**Economic and Social Council**Distr.: General  
10 February 2021

**Economic Commission for Europe****Inland Transport Committee****World Forum for Harmonization of Vehicle Regulations****Working Party on Lighting and Light-Signalling****Eighty-fourth session**

**UN Regulations Nos. 37 (Filament lamps), 99 (Gas discharge light sources), 128 (Light emitting diodes light sources) and the Consolidated Resolution on the common specification of light source categories****Proposal for amendment to the Consolidated Resolution on the common specification of light source categories (R.E.5)****Submitted by the Task Force on Substitutes and Retrofits\***

Figure 1

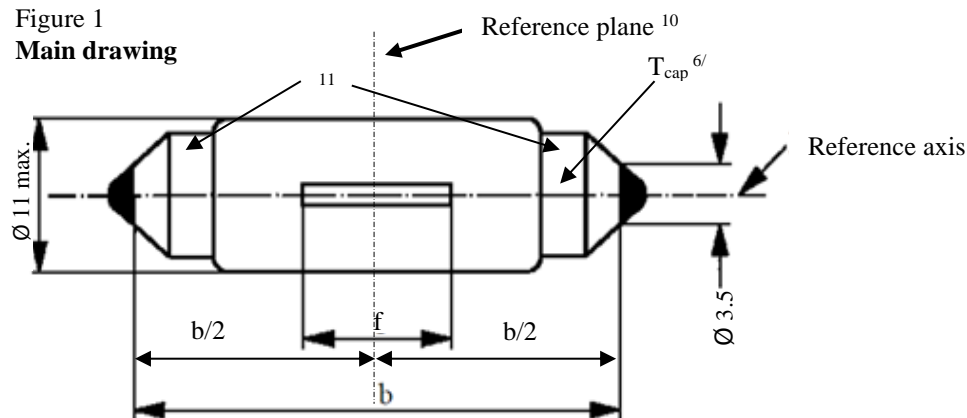
After sheet C5W1/LED/4, insert new sheets C5W\_LED<sub>r</sub>/1 to 4, to read:

The drawings are intended only to illustrate the essential dimensions (in mm) of the LED light source.

<i>LED light sources of normal production</i>	
<i>Dimensions in mm</i>			
$b$ <sup>1/</sup>		35.0 ± 1.0	
$f$ <sup>2/</sup>		9.0 nom.	
Elevated ambient air temperature <sup>4/</sup>		50°C	
Cap SV8.5 in accordance with IEC Publication 60061 (sheet 7004-81-4)			
<i>Electrical and photometric characteristics</i> <sup>5/</sup>			
Rated values		Volts	12
		Watts	3 <sup>9/</sup>
Test voltage (DC)		Volts	13.5
Objective values	Power <sup>7/</sup>	Watts	2.5 min. <sup>8/</sup> 5.5 max. <sup>9/</sup>
	Electrical current <sup>7/</sup> at 12-14 V DC	mA	150 min. <sup>8/</sup>
	Luminous flux <sup>3/</sup>	lm	45 ± 20 %
	Luminous flux <sup>3/</sup> at 9V DC	lm	9 min.
	Cap temperature $T_{\text{cap}}$	°C	75 max. <sup>8/</sup>

- <sup>1</sup> This dimension corresponds to a distance between two apertures of 3.5 mm diameter each bearing against one of the caps.
- <sup>2</sup> To be checked by a “box system”, see Figure 2.

Figure 2

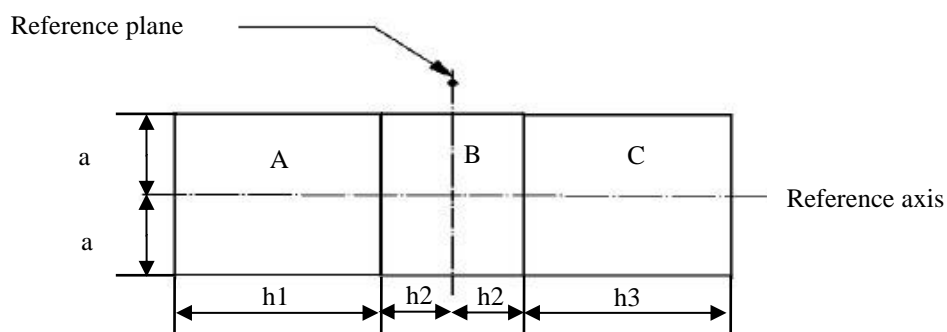
The position of the light emitting area is checked by means of a box system defined by the projections when viewing along the direction  $\gamma = 0^\circ$  (top view),  $\gamma = 90^\circ$  (front view),  $\gamma = 180^\circ$  (bottom view),  $\gamma = 270^\circ$  (rear view) in the plane  $C_0$  (C,  $\gamma$  as defined in Figure 3).

The proportion of the total luminous flux emitted into these viewing directions from the area(s) as defined in figure 2:

- A, B and C together shall be 70 per cent or more;
- B shall be 20 per cent or more;
- A and C shall each be 15 per cent or more.

These values shall be calculated as percentage of the total luminous flux emitted into the viewing direction from the maximum light source outline, i.e. a rectangle of length  $b = 36.0$  mm and a height of 11 mm, aligned symmetrically to the reference axis and reference plane (see Figure 1).

Dimension (mm)	$a$	$h1, h3$	$h2$
All views (as specified above)	2.5	6	2

Figure 3

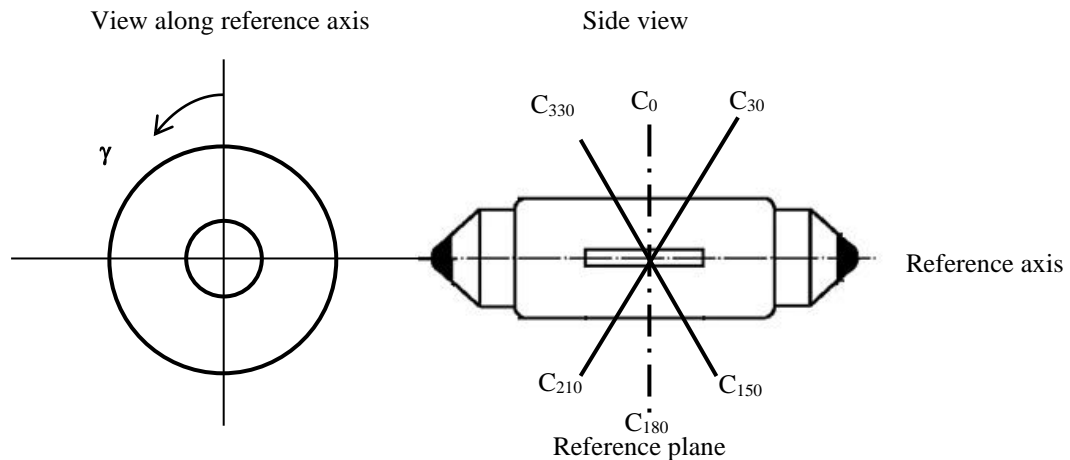
The following test is intended to determine the normalized luminous intensity distribution of the light source in the C-planes as described in figure 3. The intersection of the reference axis and the reference plane is used as the coordinate system origin.

The light source is mounted on a flat plate with the corresponding holder features. The plate is fixed to the goniometer table by a bracket, so that the reference axis of the light source lines up with one of the rotating axis of the goniometer. The corresponding measurement set-up is described in figure 3.

The measurements shall be performed in C-planes, where  $C_0$  ( $C_{180}$ ) shall be the reference plane of the light source. The C-planes to be measured shall be those specified in Table 3. The test points for each plane and multiple polar angles  $\gamma$  are specified in Table 3.

The measured luminous intensity values, normalised to the measured luminous flux of the individual light source under test, shall be converted to normalised luminous intensity values of a 1000 lm light source. These data shall comply with the tolerance band as defined in Table 3.

<i>LED light source of normal production</i>		
$\gamma$	<i>Minimum intensity in cd /1000 lm</i>	<i>Maximum intensity in cd /1000 lm</i>
0°	60	140
30°	60	140
60°	60	140
90°	60	140
120°	60	140
150°	60	140

The luminous intensity distribution as described in Table 3 shall be substantially uniform, i.e. in between two adjacent grid points the relative luminous intensity requirement is calculated by linear interpolation using the two adjacent grid points. In case of doubt this may be checked in addition to verification of the grid points given in Table 3.
